Access Compliance Report

Public Rights-of-Way

(Pedestrian Signals)

Intersection ID: N/A	Main Street:	Cross Street: N/A	Location: N/A
ADA ID: 9394508B5F7F	Signal Type: Two Push Buttons-Non APS	Overall Compliance: No	Severity Score: BTN 1:N/A BTN 2: N/A No BTN: N/A
Codes/Mitigation Info/Possible Solution		Field Measurements/Component Compliance

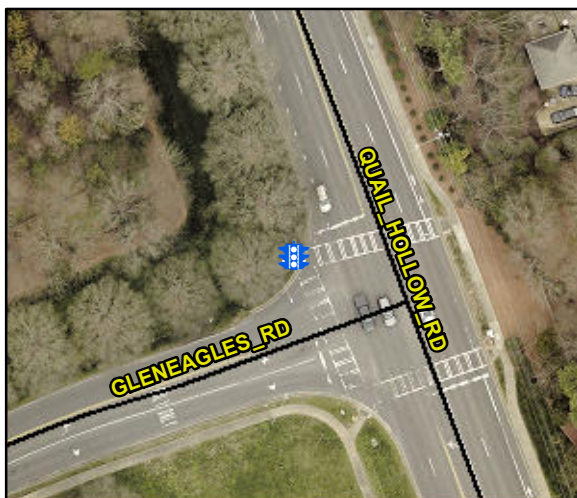
PROW/ADA: R404.3, R404.1, R404.7.1, R404.7.2

Possible Solutions: Provide PAR As Indicated. Provide Clear Space.
